# South Century Drive: Sunriver Corridor Intersection Improvements

## ONLINE OPEN HOUSE #1 Public Feedback Summary April 2025

Prepared for:  
Deschutes County

Prepared by:  
JLA Public Involvement

### Option 2: North Roundabout

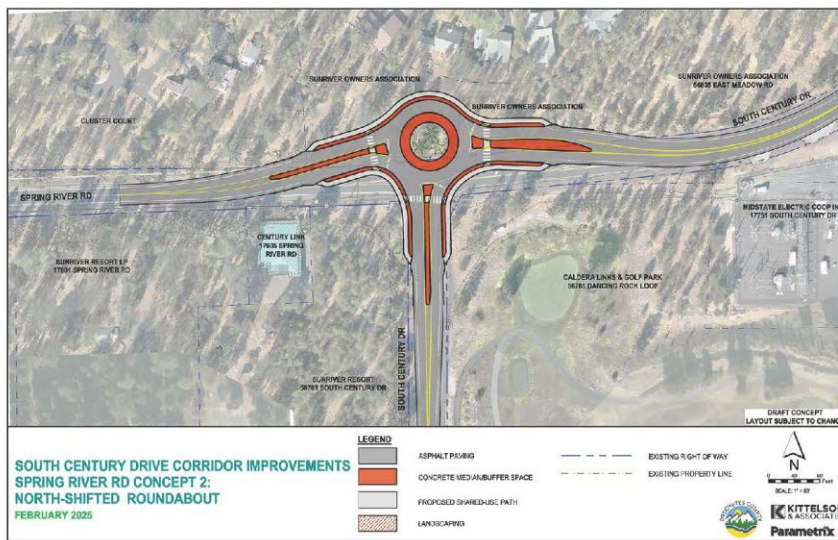
- Spring River Road's Option 2 (north) roundabout will be noisy and bothersome for residents.
- Venture Lane's Option 4 (Barbell) roundabout is preferred because it appears to affect the least amount of property and will increase bicycle and pedestrian safety because it would force people to slow down.

- Just wondering why the North shift plan at Spring River was created ? It really pushes on Pine Bough Lane. I am the owner of 3- Pine Bough, which is not affected all that much, but houses 5,6,7,and 8 are affected. I am very excited you are taking on this project since the high speeds on that stretch are dangerous.

Hi, I am the owner of 3 Pine Bough Ln, Sunriver. Thank you for letting me comment. The Concept 1 Plan for Spring River RD is the best fit, due to the use of the already road easement property. The Concept 2 Plan, does not make much sense due to an unnecessary shift to the North, which has a negative impact on Pine Bough Lane houses 5,6,7, and 8. These houses are already close to the intersection, and it is noisy already for them, and these houses were built in the 1970's. The Dancing Rock Loop Houses of Caldera are much further away and were just built in the last 10-15 years, so shifting it North into SROA property and closer to the Pine Bough houses does not make sense. Is there a reason that Concept Plan 2 even got initiated ? What about a South shift ? The Venture Lane concept 4- Barbell makes the most sense. It utilizes the current road easement property and the Barbell configuration will slow traffic since the cars entering, heading West, will have a double round about to navigate. Then be required to navigate the one at Spring River RD, and also in the opposite direction. The car speed in this stretch of road has been high and it is great you are putting in these improvements for biking, walking, and car safety. I think the other concept Plans for this interchange, at Venture LN, would lead to less speed reduction and less safety improvements. Once a car enters the Peanut, Concept-1, heading West, the driver will increase speed a lot. Same with Concept -2 , single round about. I think Concept 3-Teardrop has the same problem with a West driver increasing speed after entering, also the Teardrop pushes North and will be negative for Parkland and East Park property owners in Sunriver and be negative to SROA, taking property. Please email or call, if there is any particular reason for The Concept 2, North Shift at Spring River rd.

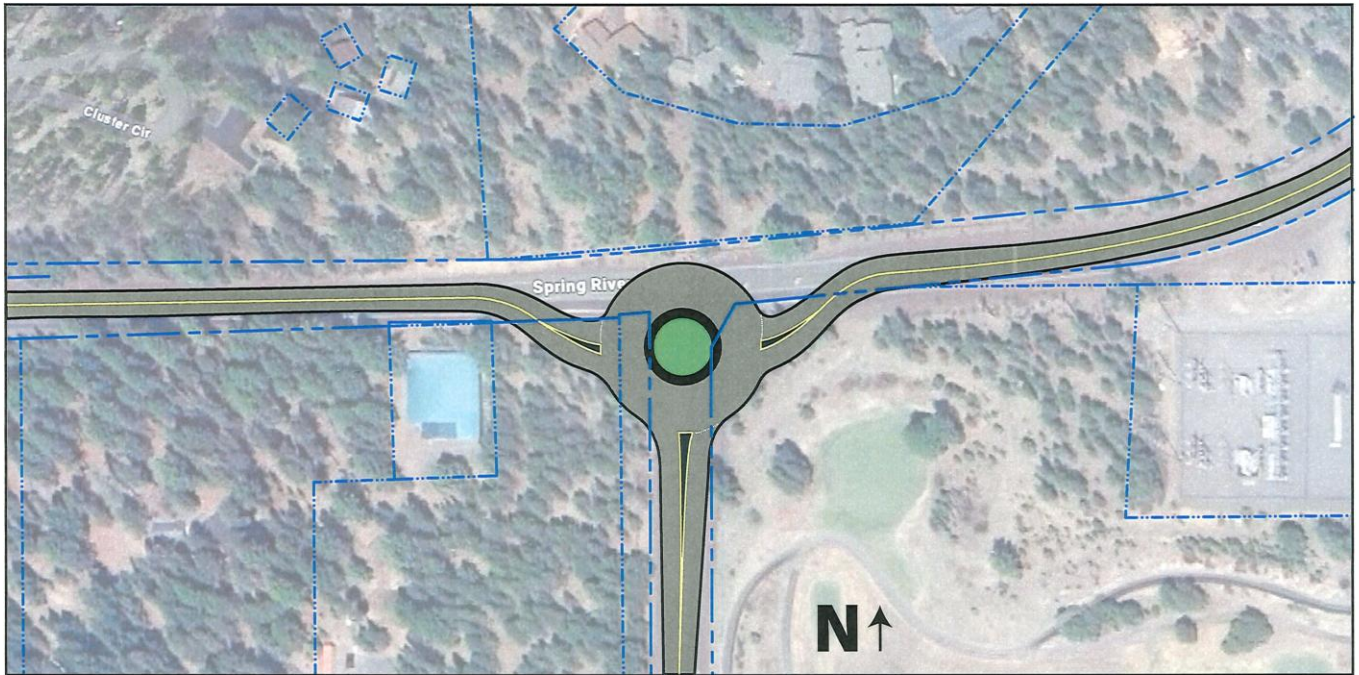
- SROA does not support and opposes the two conceptual plans provided for the South Century / Spring River intersection.
- SROA conceptual plan – recommendation

- The plan does show that the acquisition of right of way will be necessary on the southeast and southwest corners of the existing intersection, but the SROA suggested design seeks to minimize such in respect to those property owners as well. Nonetheless, we believe that the acquisition of right of way and construction in these areas will have far less “everyday” livability impacts to the adjoining non-residential development (existing and possible) than it will to the permanent residences/homes to the north.
- We recommend that the design provided by SROA be considered by the County, with the same exploration of costs, safety, traffic flow, etc. This should also occur with consideration of the other factors affecting the long-term livability, property values, etc., for residences/homes to the north.
